Response to Anonymous Referee #1 – RC3

In “Mobile measurement of methane emissions from natural gas developments in Northeastern British Columbia, Canada”, Atherton et al. describe with lucidity and apply with care an improved mobile survey technique for identifying methane leaks in an understudied region of Canada’s oil and gas fields. The measurements are used to probe which aspects of the oil and gas infrastructure in the portion of the Montney region surveyed are most likely to emit methane. A conservative estimate of the bottom up inventory for entire Montney development is calculated and compared against state-based estimates, which is the most uncertain part of the analysis. The manuscript clearly describes the measurement and analysis techniques, highlights the limitations of the approach, and contextualizes the results nicely. I recommend this manuscript for publication in Atmospheric Chemistry and Physics with only minor changes.

Figure 3. Mean distance from infrastructure while surveying each of the six routes listed in Figure 1. One standard deviation from the mean shows the range of distances at which we were sampling downwind of infrastructure.

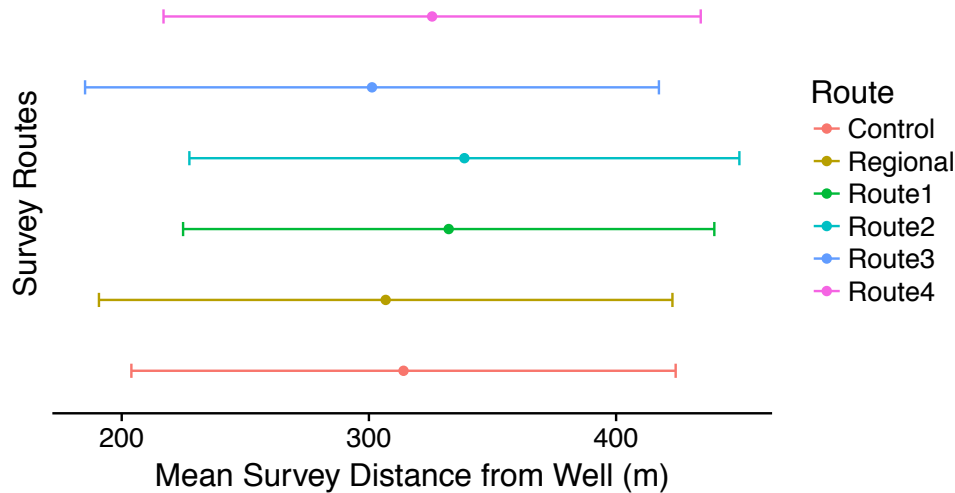
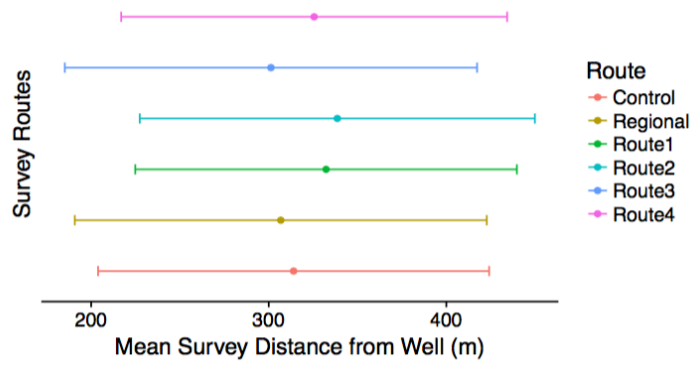
Figure 2 - If I understood correctly, industrial sources were passed on multiple routes. Could these dots and bars be color-coded (with colors from Figure 1) by the route on which the source was observed?

53. Figure 2: What are 88 industry- defined areas?

For clarity we have re-created this graph to show detection distances on each route. Below is the revised graph and caption.

“Figure 2: Mean distance from infrastructure while surveying each of the six routes listed in Figure 1. One standard deviation from the mean shows the range of distances at which we were sampling downwind of infrastructure.”

We have revised this figure to show the detection distances on each route. Please see response to Anonymous Referee #1 *Figure 2*.

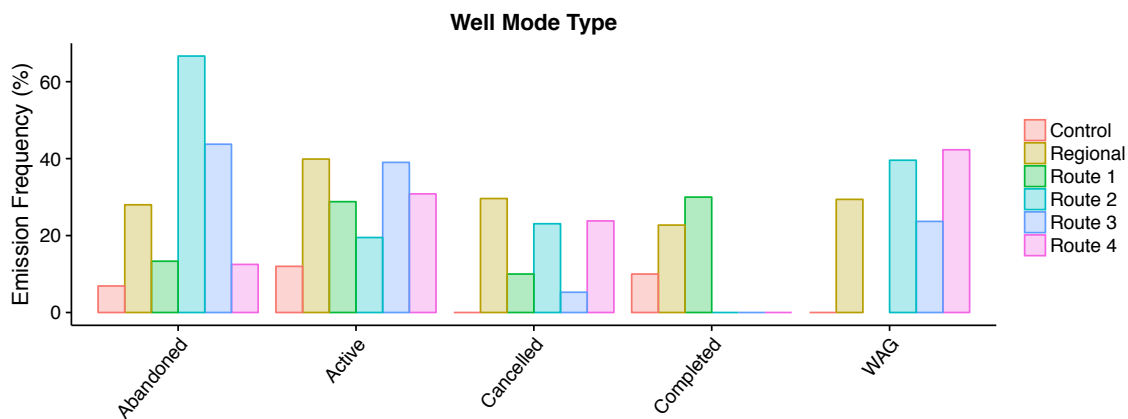
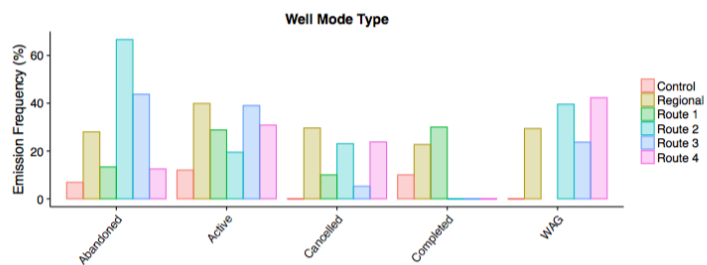
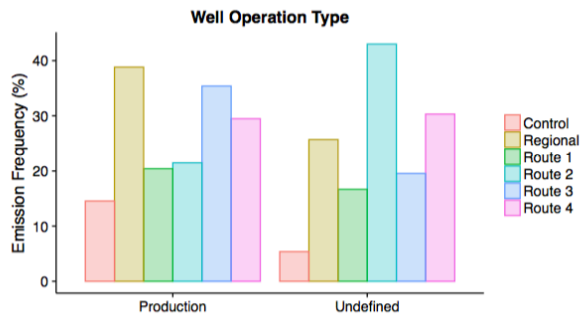
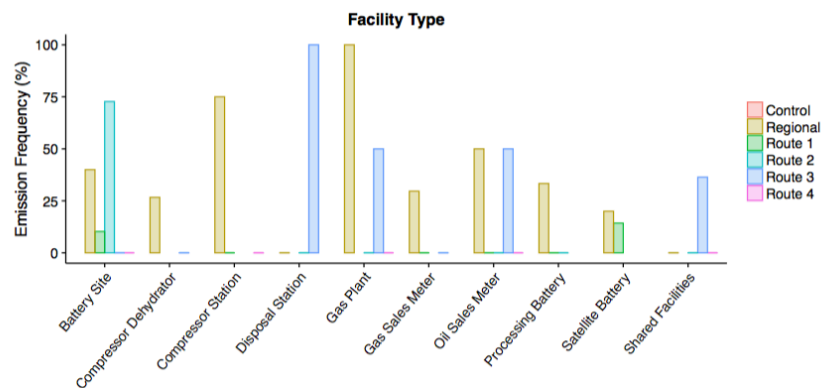
Figures 5, 6, 7 – Please add to the caption the meaning of the grey-shaded areas around the line.

Fig 5: In some panels (e.g., the top panels), the regression lines do not pass through zero. This doesn't make any physical sense. Why should there be a threshold for number of wells surveyed below which no emissions should occur? Why would there be no emissions for surveys with fewer than 60 wells surveyed? I don't understand the rationale for a linear regression. Why not simply ratio the total number of sites with emissions / total number of sites surveyed across all surveys for each category? This would make more intuitive sense. Alternatively, the linear regressions could be forced through zero, which would be similar.

Fig 6 and 7: similar comments to above for Fig. 5.

57. Figure 7: Why are there zero-zero points in this graph? Although physically a zero-zero point makes sense, I do not think the addition of the points is statistically sound. We have re-plotted the regression plots as bar graphs. Please see response to comment from Anonymous Referee #2 Fig. 5,6,7.

In response to a comment from Anonymous Referee #2 (below) we have illustrated these data using bar graphs instead.

We agree and have changed the linear regression plots to bar graphs which show the percentage of infrastructure emitting for each source-type. Please see the graphs and captions below. We have also made minor changes to the manuscript text accordingly.

“Figure 6: Emission frequencies for each well mode type for all surveyed infrastructure on each route. These emission frequencies were considered in our total emissions inventory calculations.”

“Figure 7: Emission frequencies for each well operation type for all surveyed infrastructure on each route. Certain operation types for which we did not have a

representative sample are not included (such as Injection, Disposal, and Observation wells).”

“Figure 8: Emission frequencies for each facility type for all surveyed infrastructure on each route. These emission frequencies were considered in our total emission inventory calculations.”

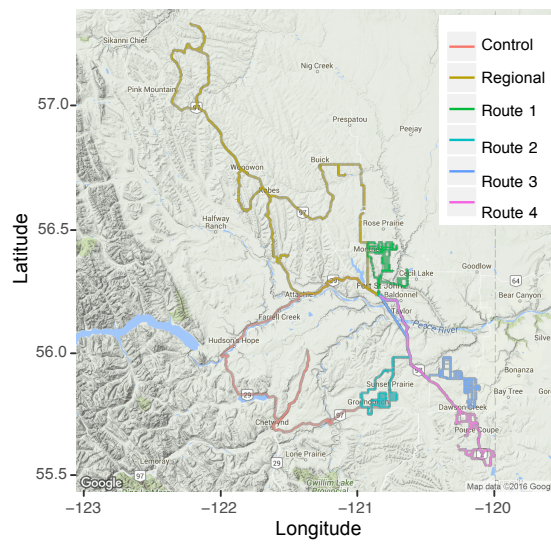
52. Figure 1: Is it possible to add the location of the wells here as a light gray background? It would be helpful in visualizing the type of routes. Also, please make sure that your designations of routes in this figure and the paper are the same. After reading through, I found TABLE 1 in Tables. Do authors mention this table in the text of the manuscript?

The map scale does not allow for the infrastructure locations to appear as individual points. The routes designations in Figure 1 are correct, and Table 1 is now referred to in the text of the manuscript in the following sections: *2.1 Field Measurements*, and *3 Results and Discussion*.

Figure 2. [Example of a regression plot that demonstrates the optimization process we used to calculate an RMRI for each survey. The RMRI for each survey was chosen where the two linear regression lines intersect.](#)

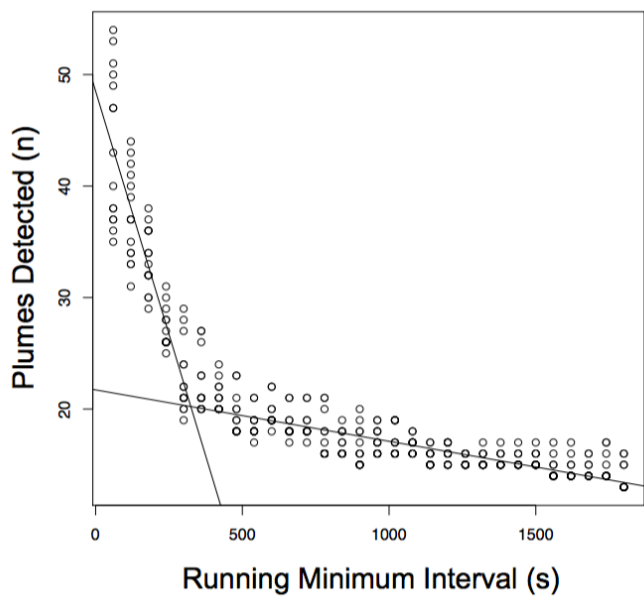
21. Page 5, Line 10-12: Please add some statistical data.

We did not choose the RMRI value for each survey subjectively. The optimization was performed with an algorithm that was applied to all surveys individually. We have added the following figure and associated text to the paper to clarify the quantitative process we used to determine the RMRI for each survey. Please see the figure, caption, and revised text below.

“Figure 2: Example of a regression plot that demonstrates the optimization process we used to calculate an RMRI for each survey. The RMRI for each survey was chosen where the two linear regression lines intersect.”

Please see answer to Anonymous Referee #2 P5 L10-12. We have added an example plot to explain our method of choosing the RMRI.

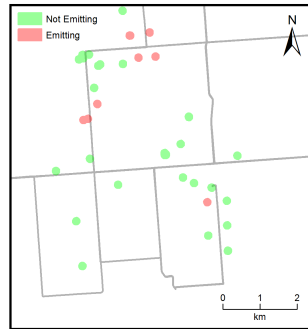
55. Figure 4: Please revise caption to explain graph better. What are the gray lines?
The gray lines are surveyed roads. This is now explained in the caption.

The source location databases were up to date at the time we retrieved them (July, 2015). Locations of the majority of sources in the database near our surveys were verified during the on-ground survey campaigns. A section has been added to the manuscript about the uncertainty in infrastructure inventory in response to a comment from Anonymous Referee #1 p9 1.7-8. We have also reworded the caption of Figure 4 (now Fig. 5 in revised manuscript) for clarity.

“Figure 5: A subset of infrastructure locations that we surveyed during our field campaign in attributed form. This figure serves as an example of how we attributed wells and processing facilities to on-road plumes. Grey lines represent the survey route. In this case 31 wells or facilities were surveyed, and we used our attribution technique, which accounts for wind direction and distance to source, to determine whether or not these wells and processing facilities were probable emission sources.

Figure 10. Effect of infrastructure age and operator size on detected emissions. The sizes of the dots represents number of samples taken. Red dots are those recorded at the 100% persistence level, green dots are at 50% persistence.

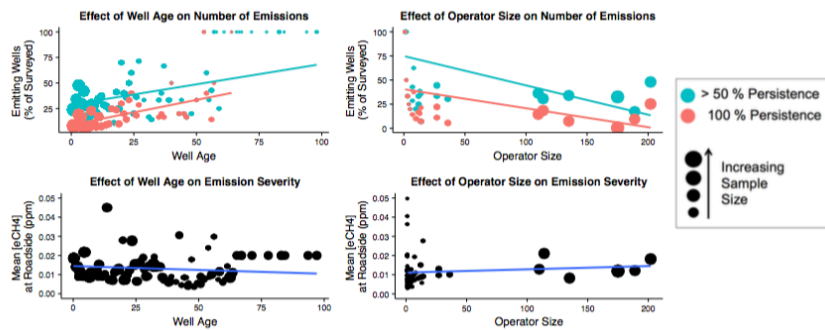
58. Figure 9: Please add numbers in the increasing sample size legend. Were any of the wells in this area re-worked? This will change the definition of well age in this discussion. We have not added numbers to the increasing sample size legend because each graph in the figure has a slightly different scale. However, one legend for sample size without numbers is sufficient because it is only meant to show the relative number of times we sampled infrastructure in each category. We did not have information on whether or not wells were re-worked.

(This is now Figure 10 in the revised manuscript). We have removed the grey error bars from this figure. Below is the edited caption.

“Figure 10: Effect of infrastructure age and operator size on detected emissions. The size of the dots represents the number of samples taken. Red dots are those recorded at the 100% persistence level, green dots are at 50% persistence.”

Figure 10. Distribution of emitting infrastructure by industry-defined area. The size of the circles represents the number of measurements we took downwind from individual wells or facilities in each area. The colour of the circles represents the frequency of emitting infrastructure in each area.

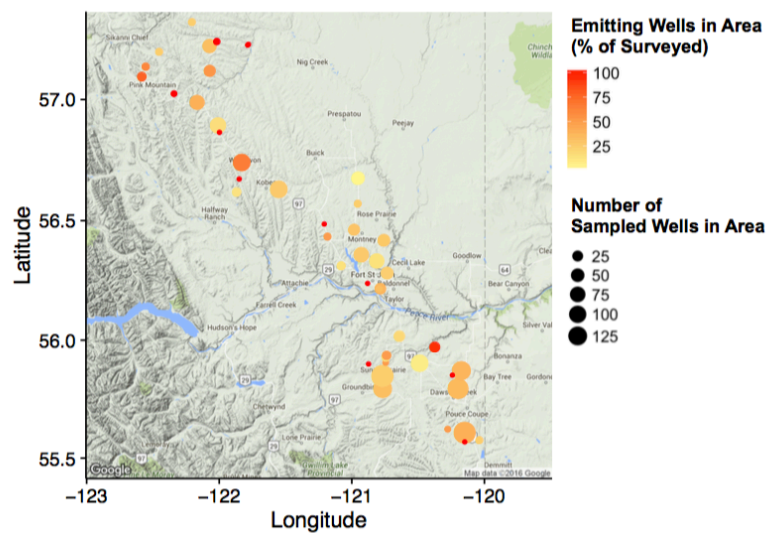
Fig 10: could you add in the survey paths on this plot for reference?

(This is now Figure 11 in the revised manuscript). We have chosen not to add the
